# Modification to Minister's Approval

Application Number: MP 06\_0228  
Proponent: Shoalhaven Starches Pty Ltd  
Approval authority: Minister for Planning  
Project: Shoalhaven Starches Expansion Project  
Date of original approval: 29 January 2009  
Modification: MP 06\_0228 MOD 9 – Packing Plant

49. Inserting a new Appendix 2I after Appendix 2H as follows:

**MANILDRA GROUP - NOWRA  
PROPOSED SOUND BARRIER WALLS**

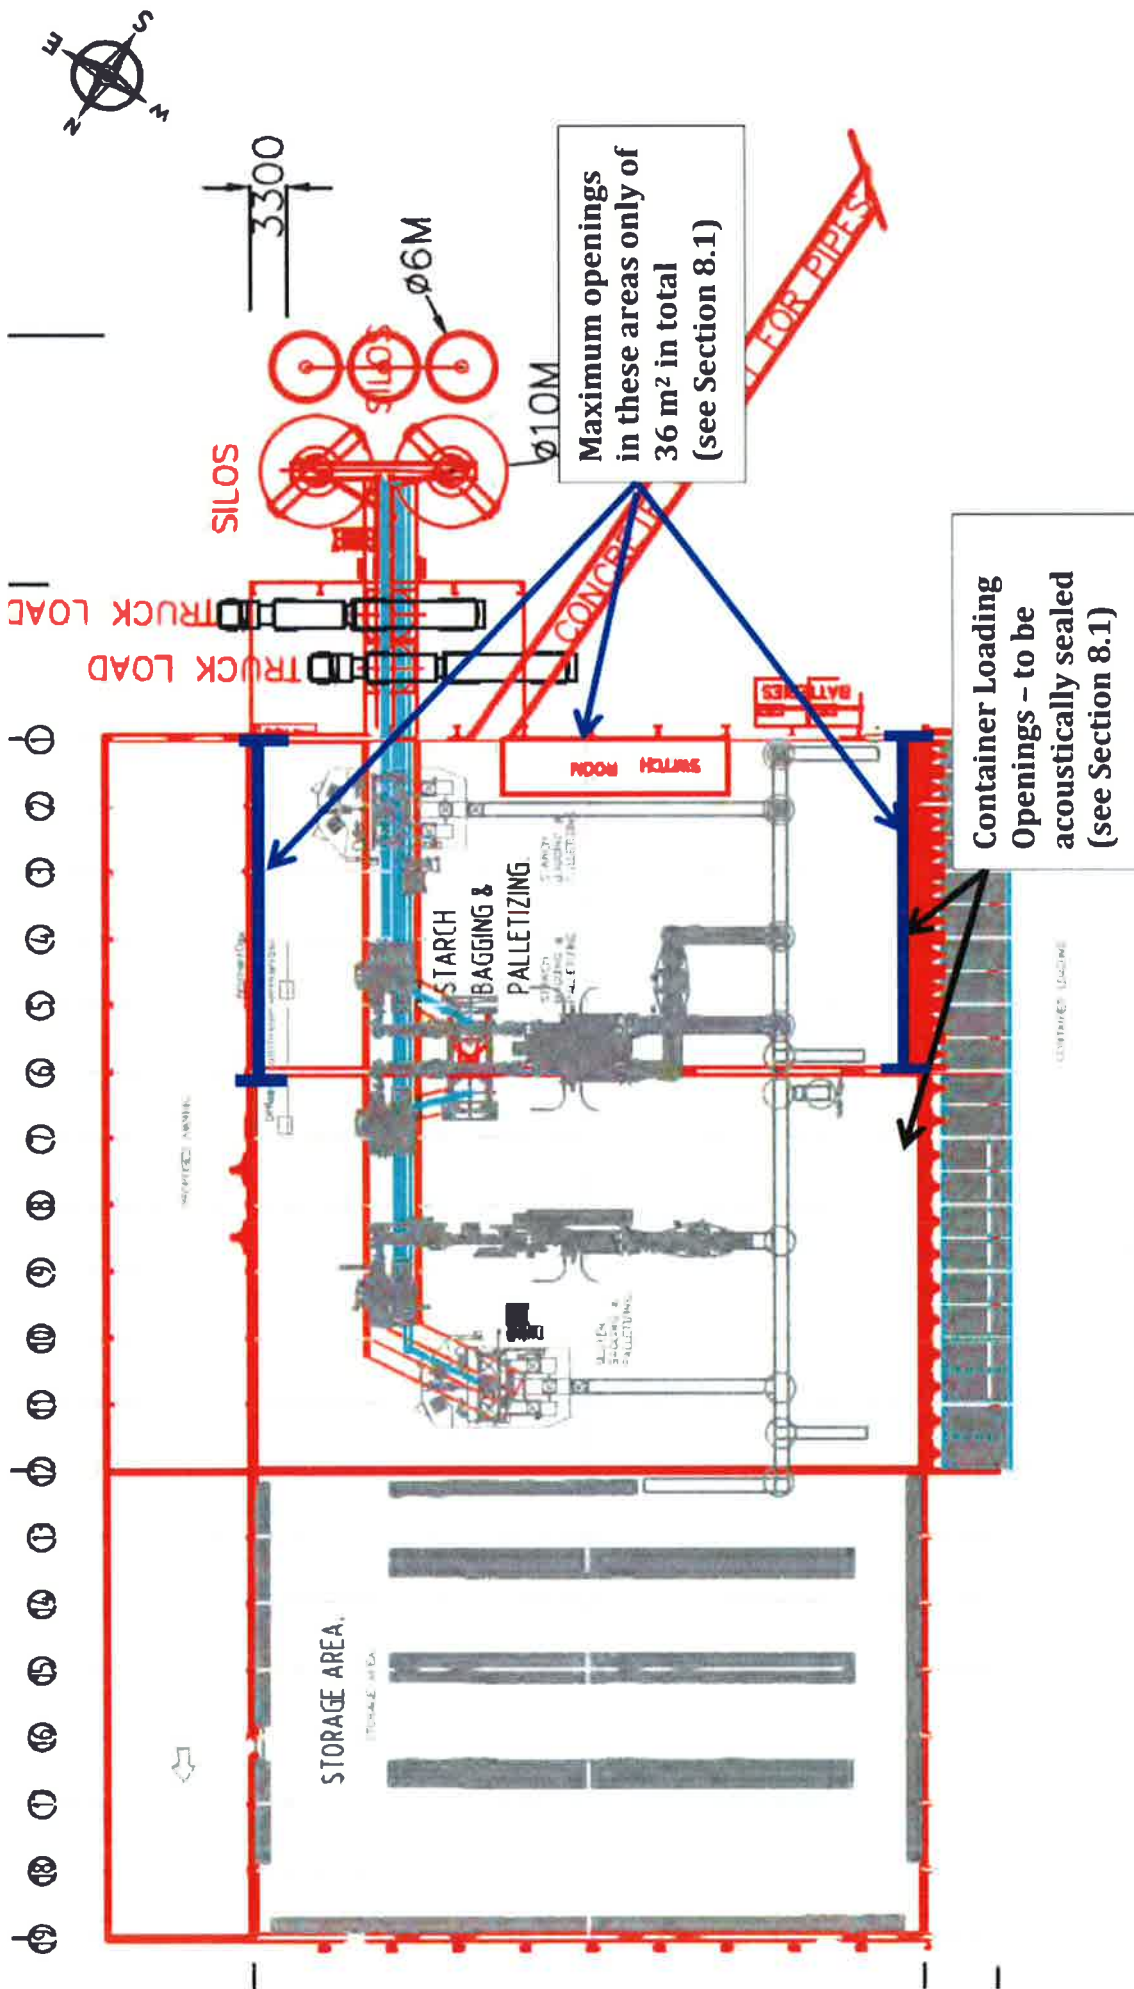
- e) permanent sound barriers a minimum 11 m high relative to the finished ground level of the container storage yard. Barriers shall extend along the entire length of the north-western boundary of the container storage area, connecting to the packing plant along the north-eastern boundary (see the figure in Appendix 2I);

- f) permanent sound barriers a minimum 9 m high relative to the finished ground level of the container storage yard, along the south-western side of the rail spur lines, as shown in the figure in Appendix 2I; and

- g) sound barriers shall be constructed as solid masonry walls, or other equivalent material, without holes or gaps, other than a maximum of 50 mm at the base.

FIGURE 8.10 Location of Building Openings

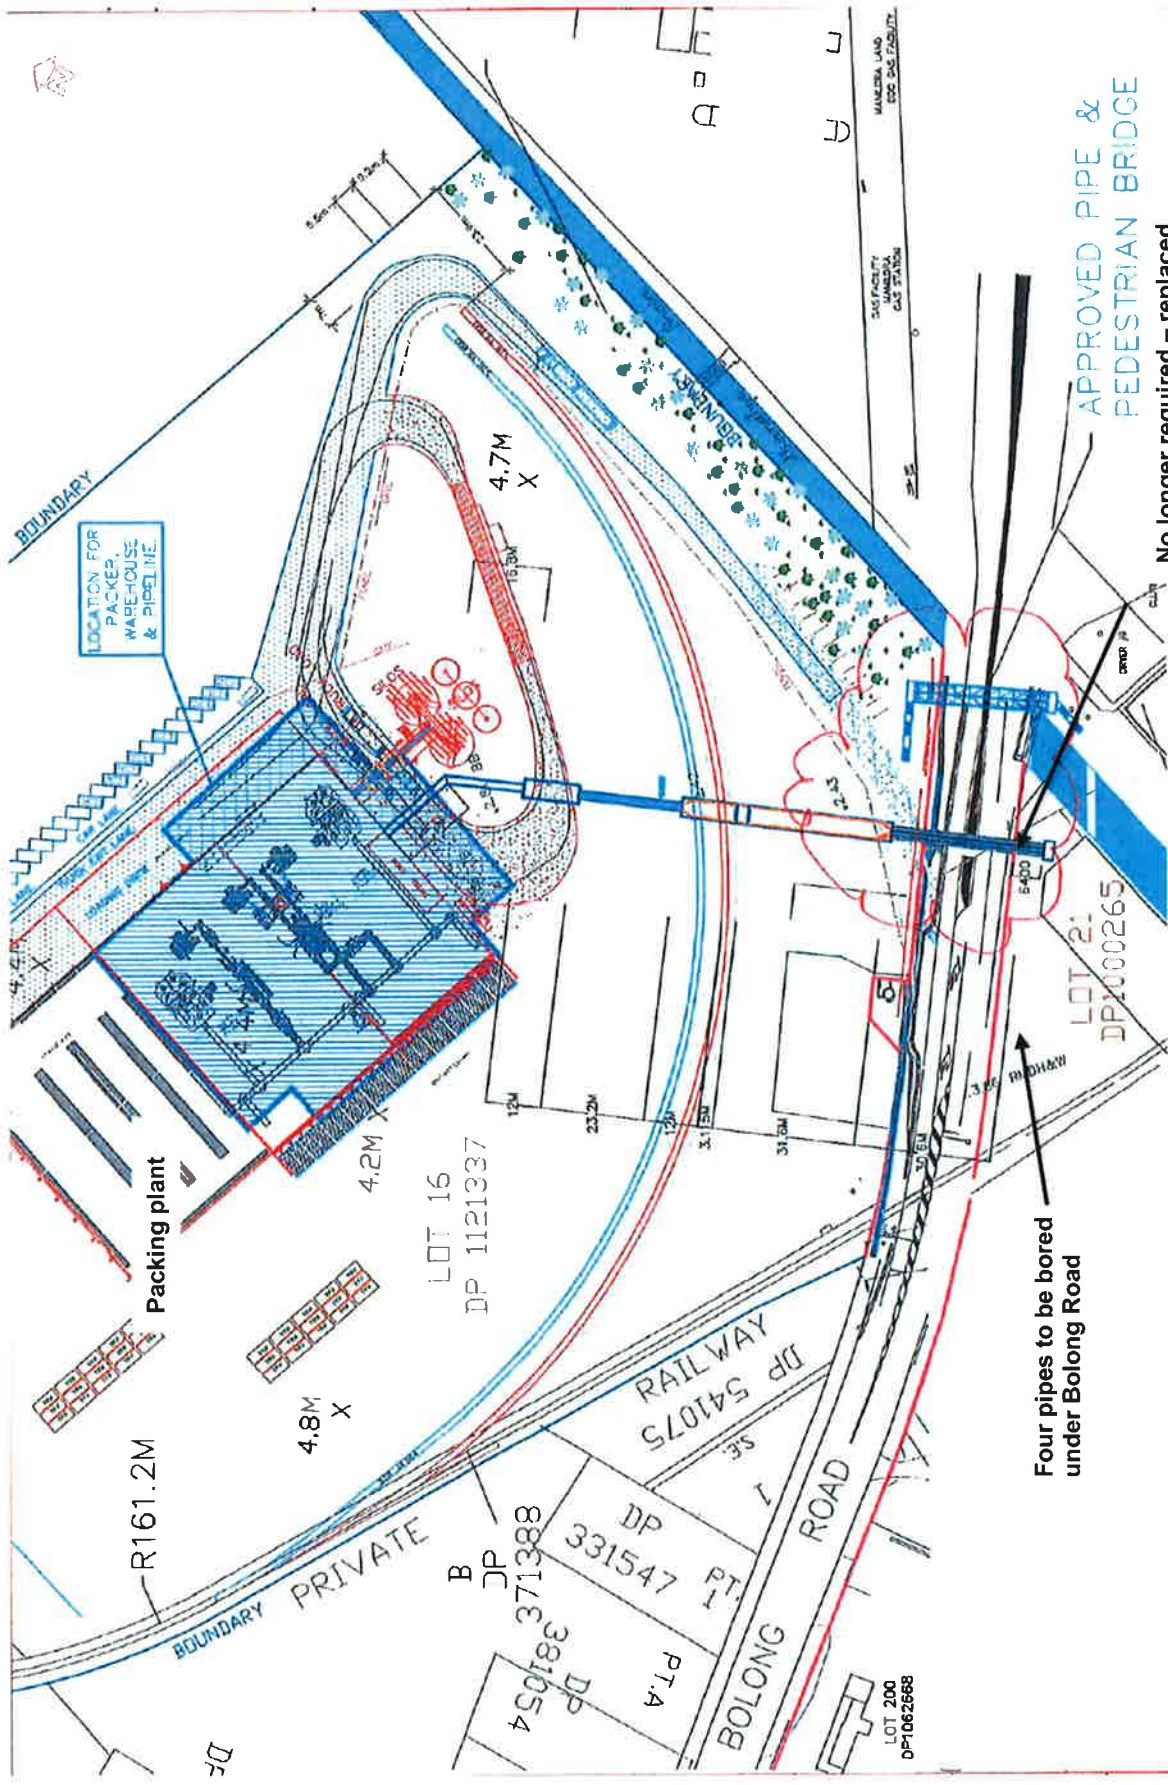
- b) all external doors are a minimum 44 mm thick, solid core timber construction, or equivalent material, in well-sealed frames;
  - c) building openings without acoustic treatments shall not exceed 36 square metres and shall be located in the south-eastern part of the packing plant building, as shown in Appendix 2I;

APPROVED PIPE & PEDESTRIAN BRIDGE

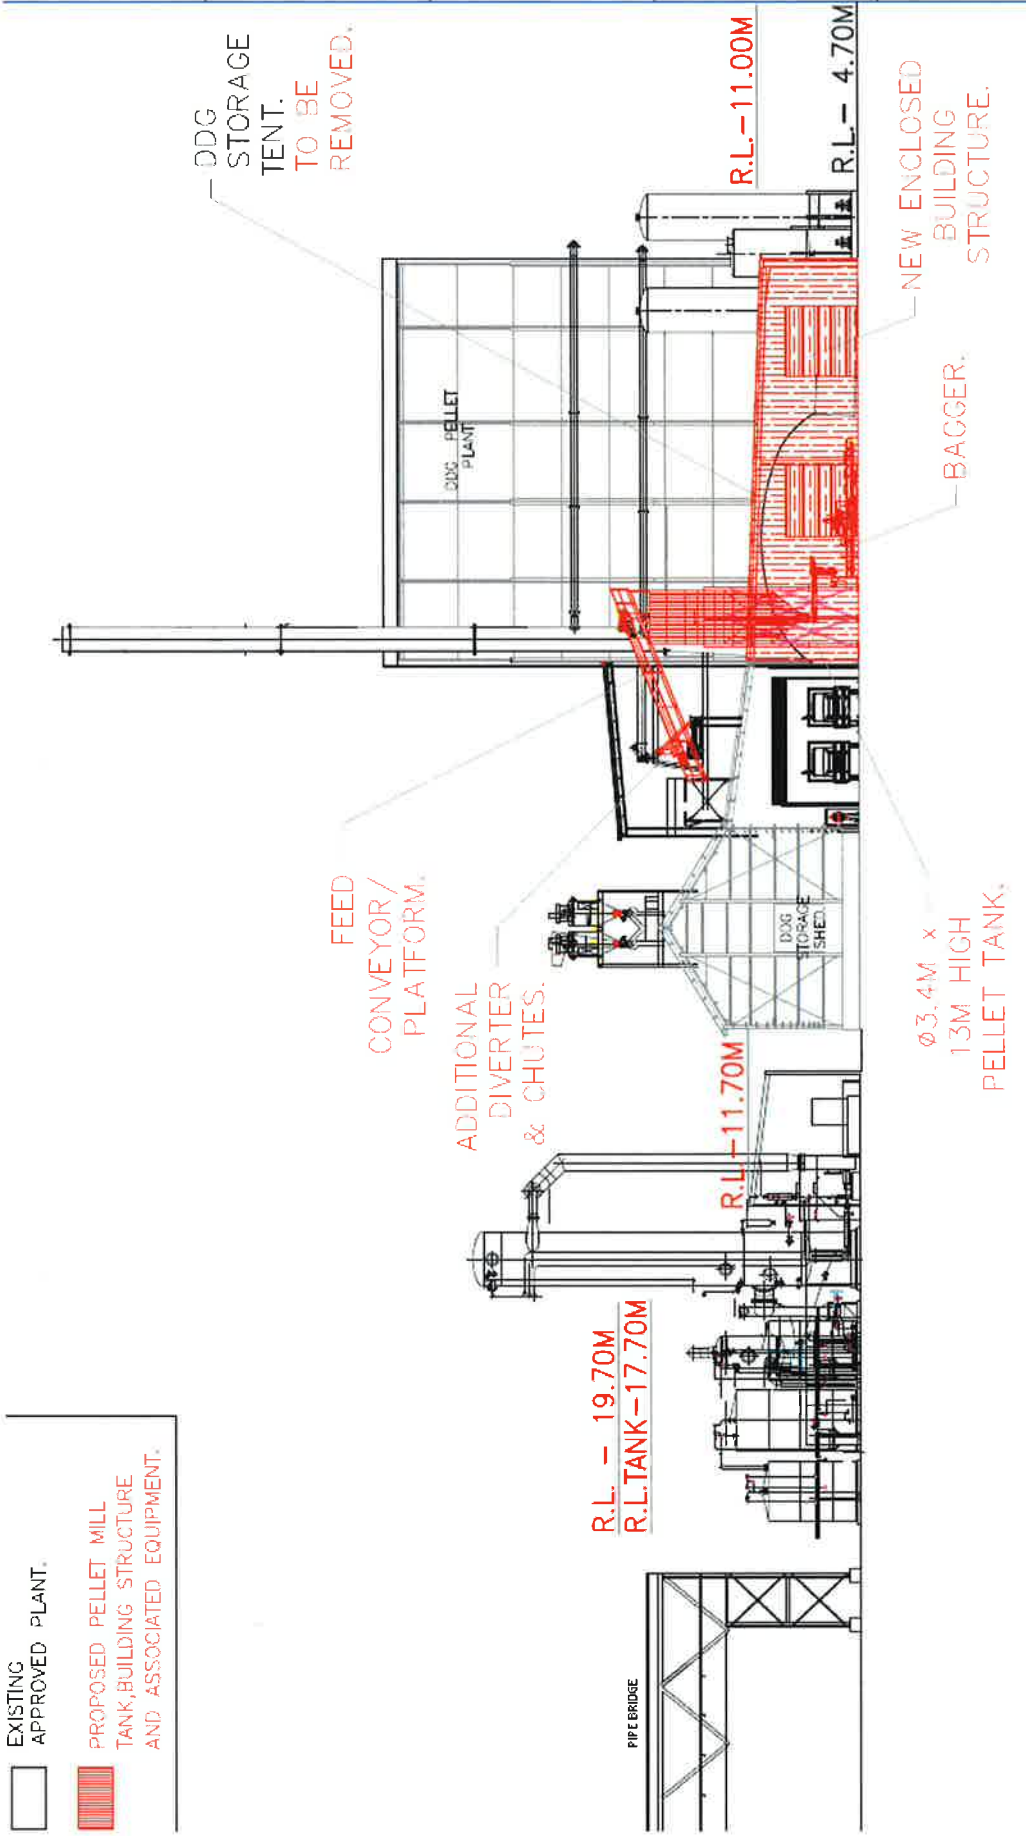
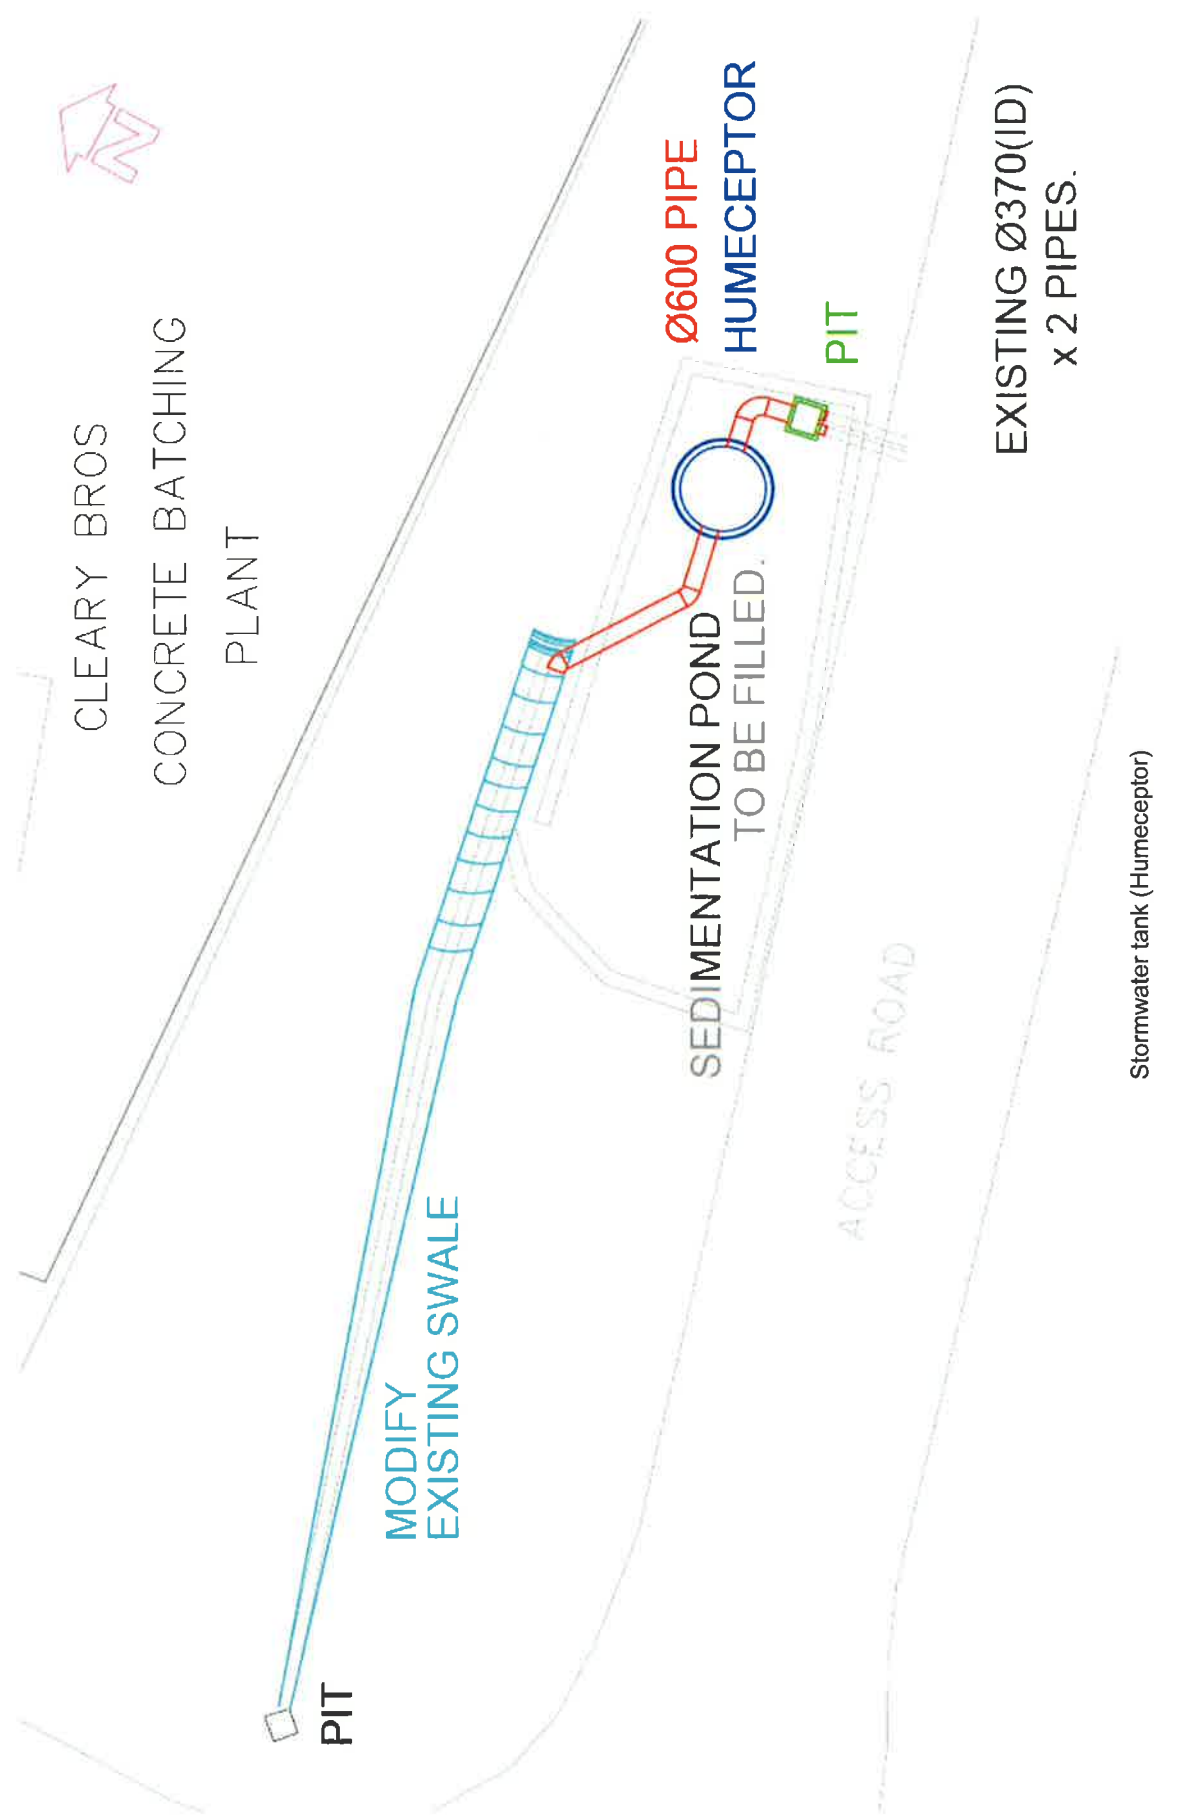
- 10A. The Proponent shall:
  - a) consult Telstra and Jemena during preparation of detailed design for the under-boring of pipework under Bolong Road as described in MOD 9;
  - b) contact Telstra and Jemena at least two weeks prior to the commencement of the under-boring works;
  - c) ensure that mechanical excavation or boring works are undertaken in accordance with the requirements of Telstra and Jemena in order to protect the private infrastructure assets; and
  - d) complete restoration works to the ground surface and footpath.

No longer required - replaced by pipes under Bolong Road

Under-bore pipes under Bolong Road
